An Environmental Impact Statement (EIS) was prepared on behalf of the proponent, Macquarie Corporate Holdings Pty Ltd (Macquarie), in support of a detailed 'Stage 2' State Significant Development Application (SSD DA) (18_9270) for the construction and operation of Over Station Development² (OSD) located above and integrated with the northern entry of the Sydney Metro Martin Place Station. The EIS and accompanying documents were placed on public exhibition from 11 October 2018 and 7 November 2018. Public exhibition occurred in accordance with the requirements of the *Environmental Planning and Assessment Act 1979* (EP&A Act).

The revised supporting documentation will enable the Department of Planning and Environment (the Department) to complete its assessment of the proposal. This report should be read in conjunction with the EIS prepared by Ethos Urban and dated 4 October 2018, as relevant.

2.0 Key issues and proponent's response

Figure 1 Street frontage design response considered in the approved Concept Proposal (and Stage 1 Amending DA)

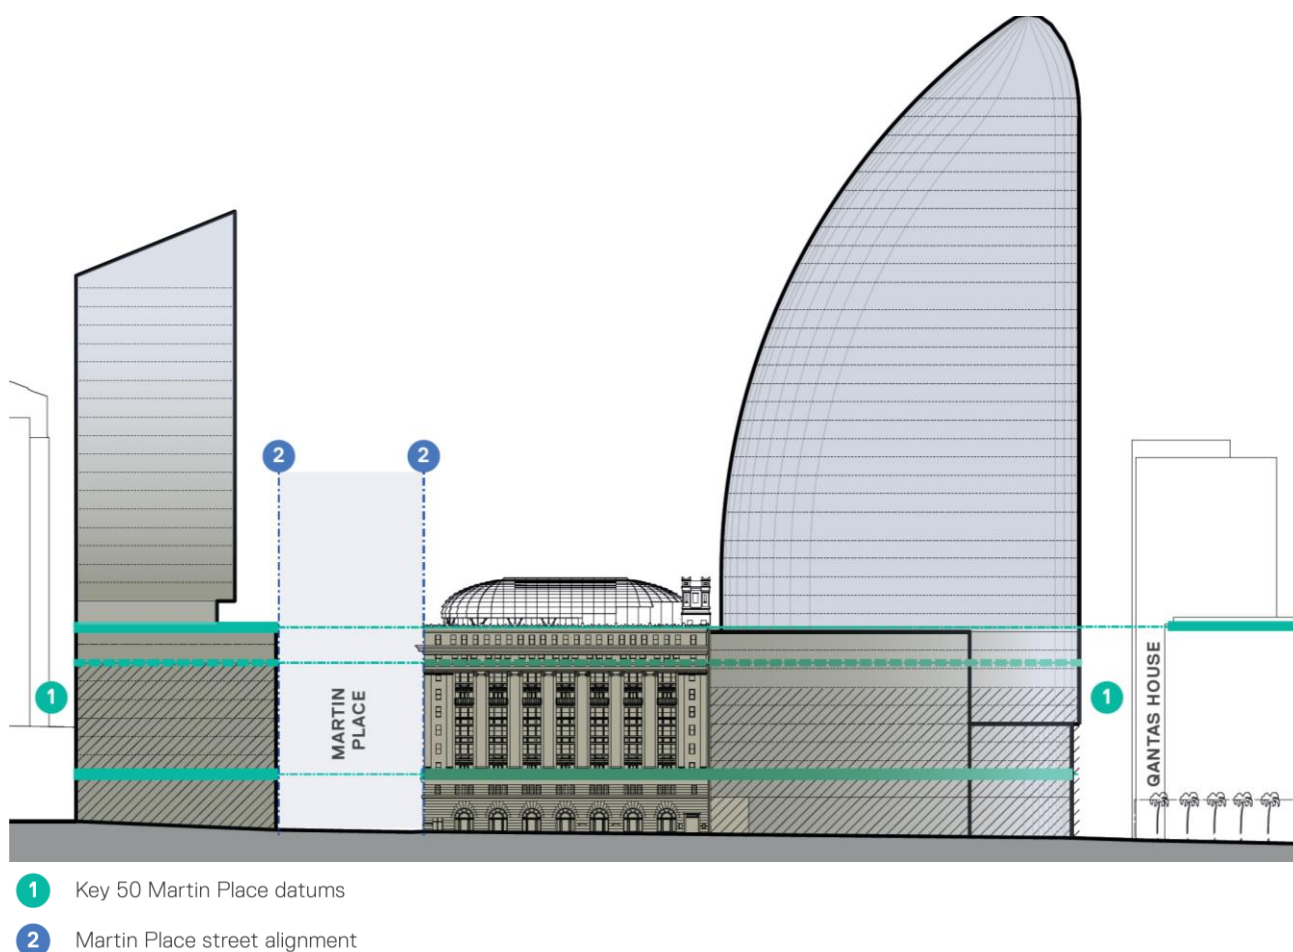
The Department requested that further justification and illustrations be provided to detail how the proposal reinforces the street frontage conditions along Elizabeth Street and Castlereagh Street and how the proposal integrates with the lower scale of 50 Martin Place.

Figure 1 below was referenced as part of the approved Concept Proposal and Stage 1 Amending DA and represented how a potential Stage 2 illustrative scheme could reinforce the street frontage conditions along Elizabeth Street through the reinforcement of the street frontage height datum discussed above.

Figure 16 Tapered and separated facade of the North Tower interfacing with 50 Martin Place, as viewed from Castlereagh Street

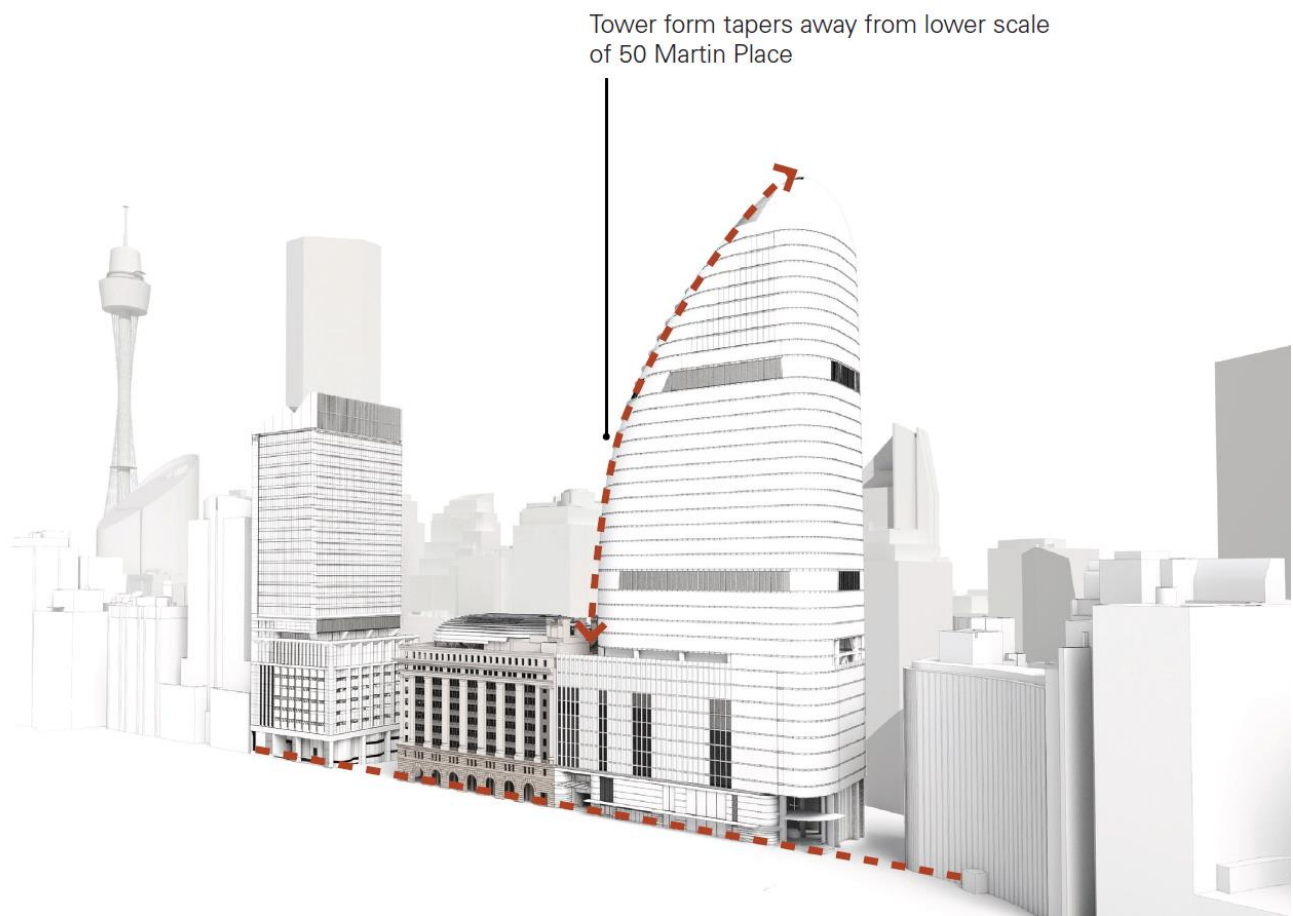
The Department requested that further justification and illustrations be provided to detail how the detailed design mitigates the bulk and form of the building, including the appropriateness of, and options for, any tower setbacks within the maximum building envelope as part of the approved Concept Proposal (SSD 8351).

This 6m setback is enhanced by a tapered southern facade that further steps the tower form away from 50 Martin Place. The tapering of the southern facade progressively increases the distance between the tower and 50 Martin Place as the tower increases in height, intensifying the visual and physical separation between these two buildings. This design response gradually and comfortably transitions the lower scale 50 Martin Place to the scale of the proposed tower behind, and complements the proposed 6m setback by preserving the existing scale of 50 Martin Place when viewed from Castlereagh Street and Elizabeth Street (see **Figure 16**).

- The tower has been set back 6m from 50 Martin Place above the building podium, and adopts a negative infill curtain wall at the junction between 50 Martin Place and the podium. These treatments visually and physically separate the North Tower from 50 Martin Place, to the extent that the lift overruns and roof form of 50 Martin Place remain a prominent feature in the streetscape. This separation between the two buildings ensures that these structures read as separate and distinct elements, breaking up the building massing and reducing the overall bulk and form of the proposal, and has been developed in consultation with the DRP (refer to **Figure 16** above).

Figure 27 Relationship of proposal to 50 Martin Place in terms of materials and articulation

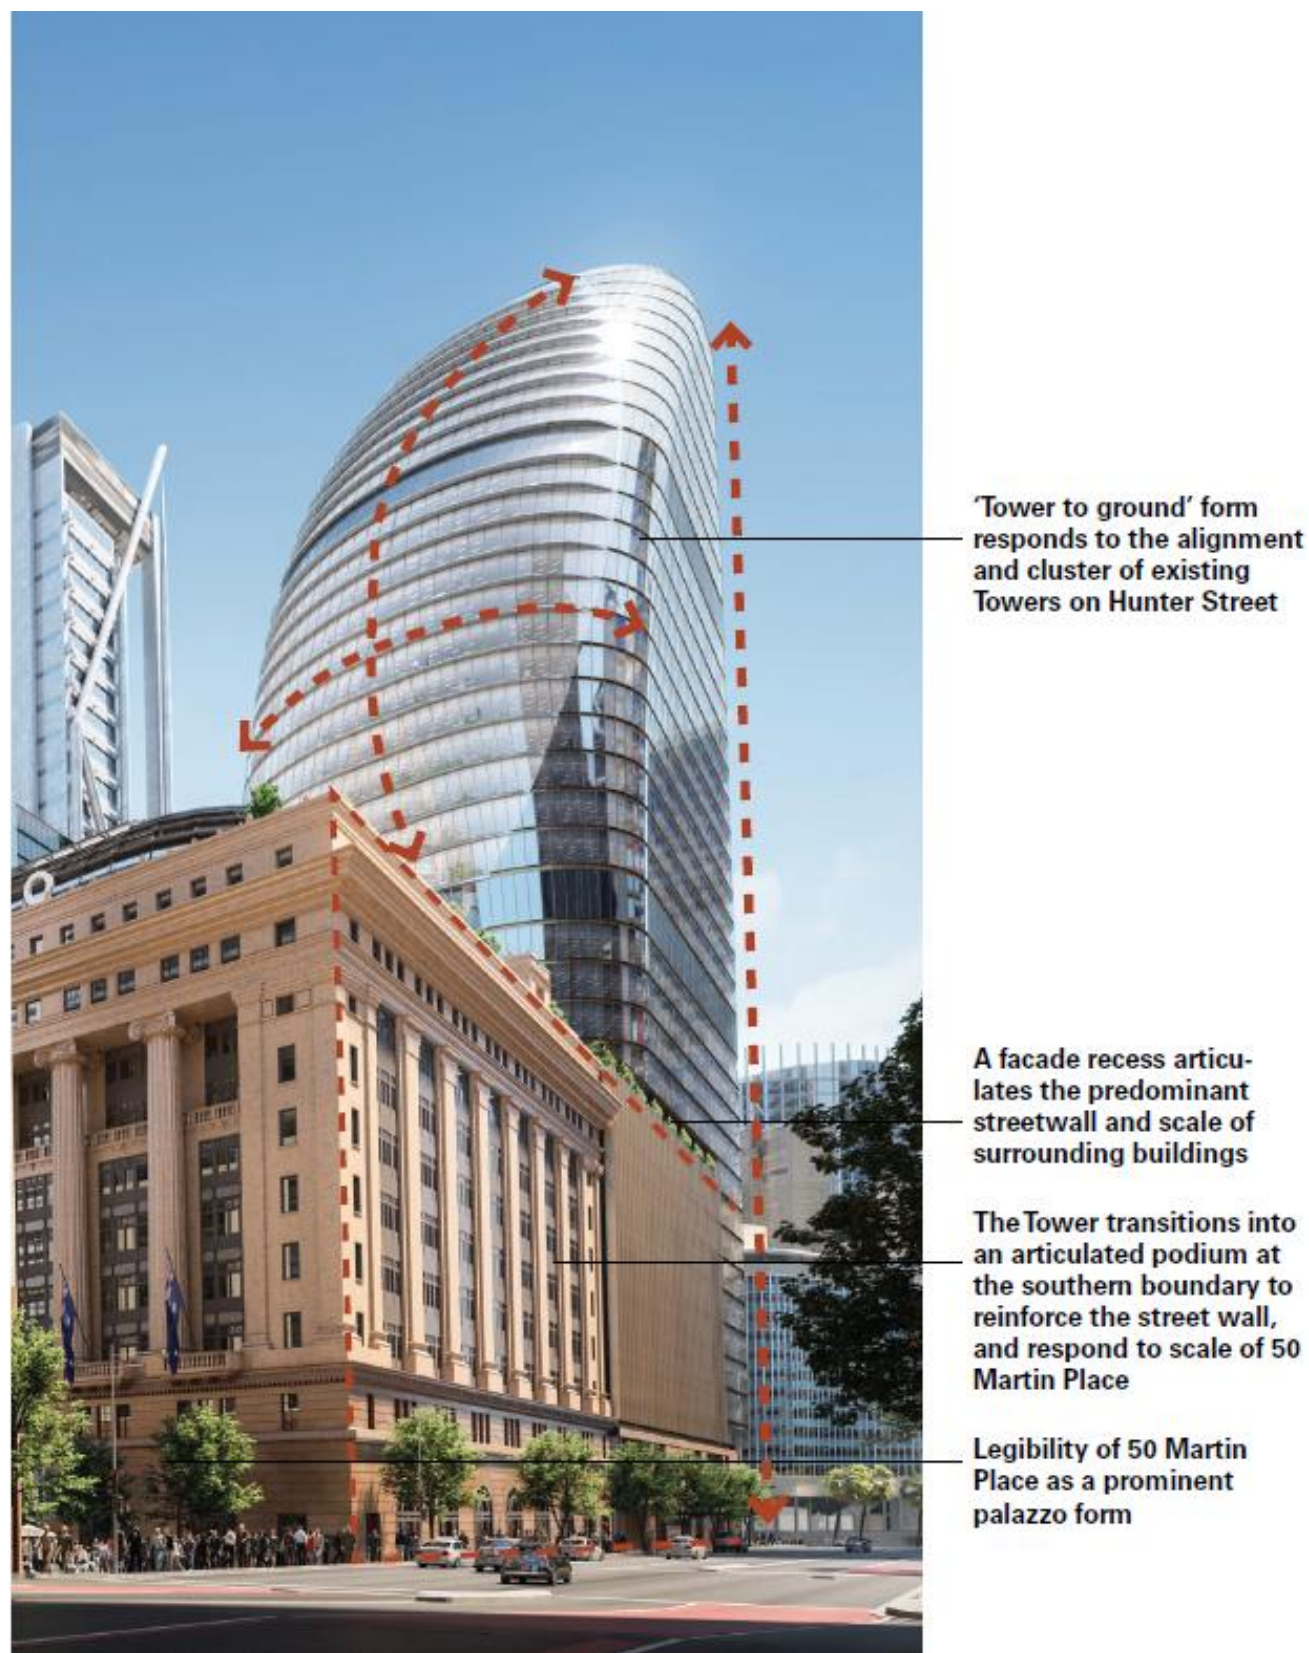
The Department has requested that further justification and illustrations be provided to clarify how the proposed podium articulations, materials, and finishes complement building proportions and the architectural details of surrounding buildings.

The proposed podium has been designed with reference to 50 Martin Place, which it directly adjoins, and forms the primary address and architectural 'anchor' for the North Site. The proposed podium forms a contemporary interpretation of the detailing and proportions of 50 Martin Place. It is designed with zero setbacks to 50 Martin Place, Castlereagh Street, Elizabeth Street and Castlereagh Street to create a defined street edge and consistent street wall on the street frontages, aligned with the footprint of 50 Martin Place.

The base of the podium has been finished in stone cladding and bronze anodised framing to match the granite and bronze framing of the 50 Martin Place base. This creates a direct visual link to 50 Martin Place at street level and creates a continuous 3 storey human scale. Above the base, vertical aluminium fins are used mirroring the pilaster columns on 50 Martin Place and provide elements of vertical expression. These fins are finished in warm terracotta colouring to reflect the terracotta tiling in the 50 Martin Place facade. Together, the fins and granite base refer directly to the grand order of 50 Martin Place, extending the character of this masonry facade by referencing key horizontal and vertical alignments in complementary materials (see **Figure 28** below).

Figure 40 Secure entry locations out-of-hours (Elizabeth Street level)

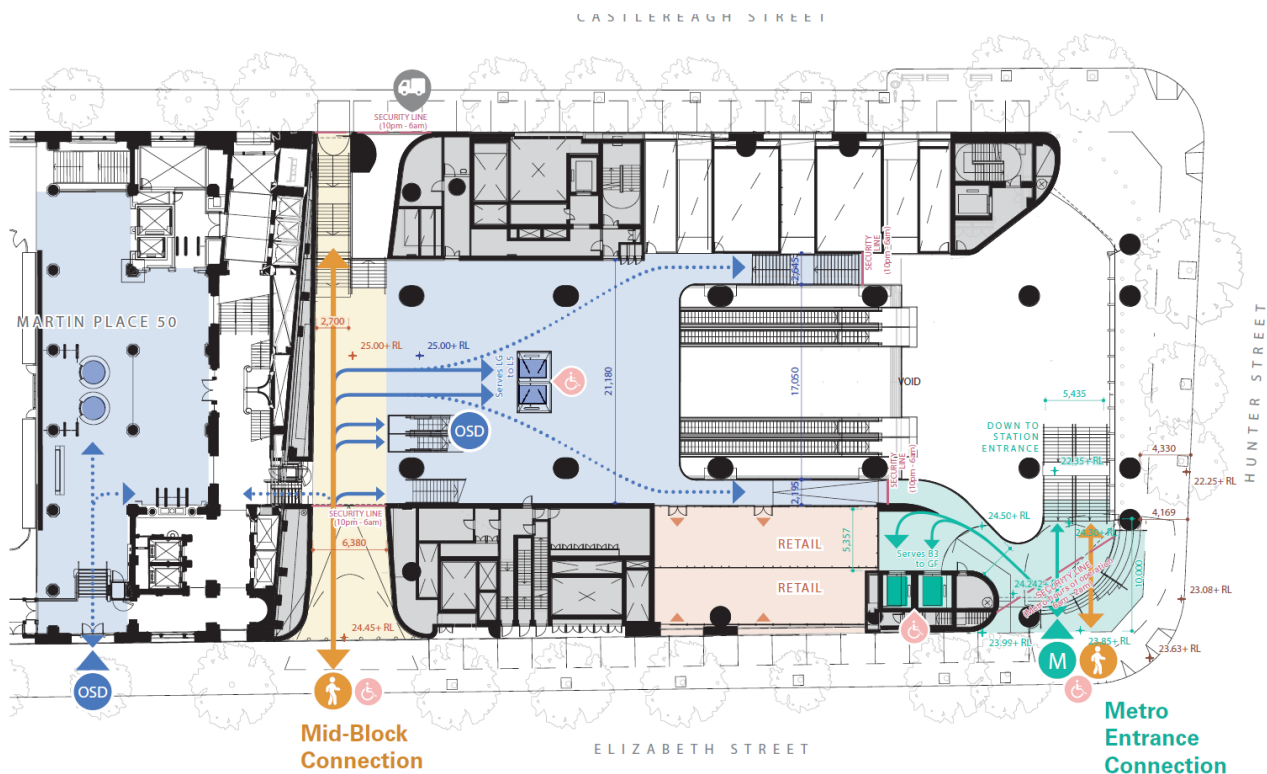
- Provide details on the operation of publicly accessible areas.
- Provide details on sightlines and passive/active surveillance of the through-site link, lift lobbies, visual connection from Martin Place (*relevant to the South Tower only*) and the streets to retail spaces and other publicly accessible areas.
- Consider the use of spatial design and visual cues to delineate between semi-private/secured access to office towers for retail spaces and publicly accessible areas as preferred options over potential security barriers.

The through-site link will operate between 6am to 10pm, in accordance with the standard hours nominated in the Sydney DCP 2012, and having consideration to benchmark operating hours and Macquarie operational and security requirements. During these hours, the link has been designed to encourage unimpeded access by the general public. Outside of these nominated hours, entrances to the link will be controlled with security gates as access control barriers. These security gates will not impact access to the Station entry via Hunter Street, so that the metro station remains accessible when operating before 6am and after 10pm, thereby not impacting access to public transport via the North Site. Refer to **Figure 40** below.

Figure 43 Quantum of active street frontages of the North Site (Lower Ground Floor)

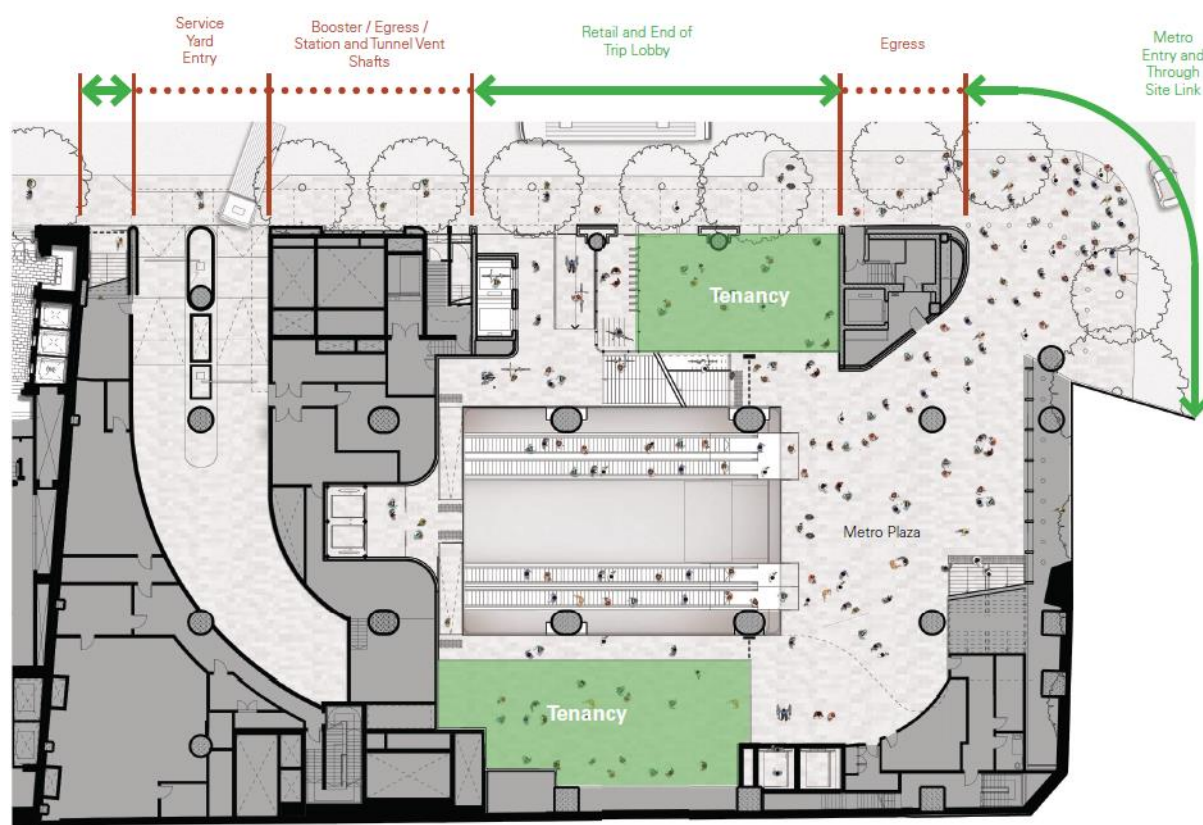
Council has raised a concern that the tower has been designed to create internal amenity at the expense of the amenity of the public streets that are faced with services, lifts and ducts. It asserts that the Elizabeth Street frontage of the building is compromised by services and the predominance of steps and ramps and that the floor level be reviewed to provide grade entry from Elizabeth Street to station lifts and building lobbies.

- Pedestrian circulation is prioritised through large and voluminous entries to the station and OSD and the proposed through-site link. Providing these openings and maximising pedestrian circulation and permeability at the ground plane is essential to the successful and safe operation of the station and OSD, and contributes to the activation of these frontages. As illustrated in **Figure 44** below, pedestrian entrances occupy a significant proportion of the ground plane including the entire Hunter Street frontage and parts of the Elizabeth and Castlereagh Street frontages.

Figure 48 Proposed material change to the through site link southern wall

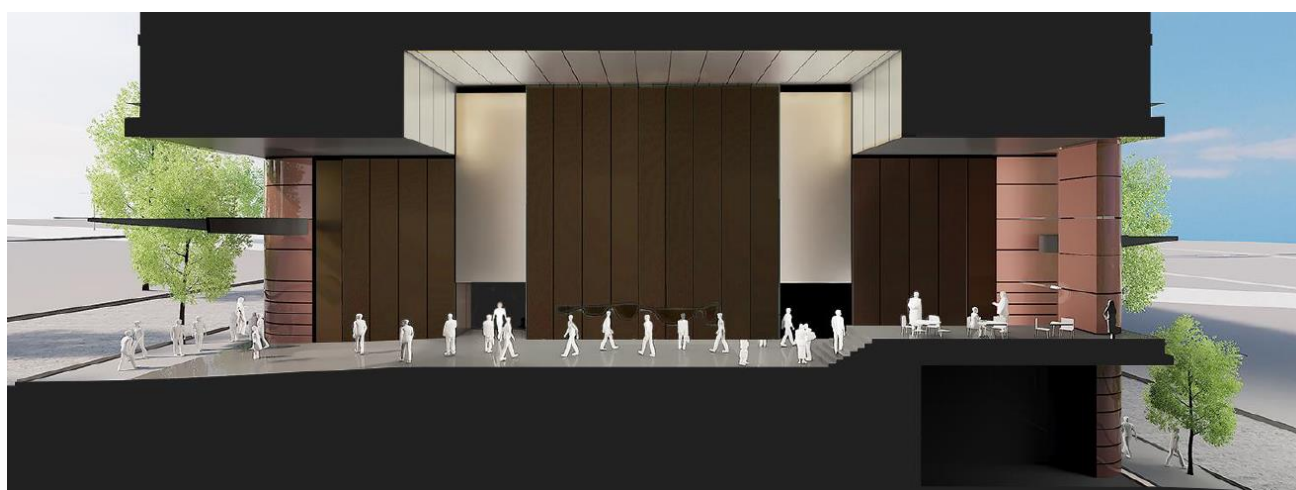
- change in proposed colour scheme for the through-site connection and commercial OSD lobby to better reflect the proposed character for this space and integration of the heritage artworks (in response to DRP feedback);
- reduction in signage zones from three (3) as originally proposed to two (2) zones on the northern and western facades of the tower; and
- rationalisation of bicycle parking and end of trip facilities to reflect the future occupancy of the building.

The figures below illustrate the changes to the design associated with this RTS.
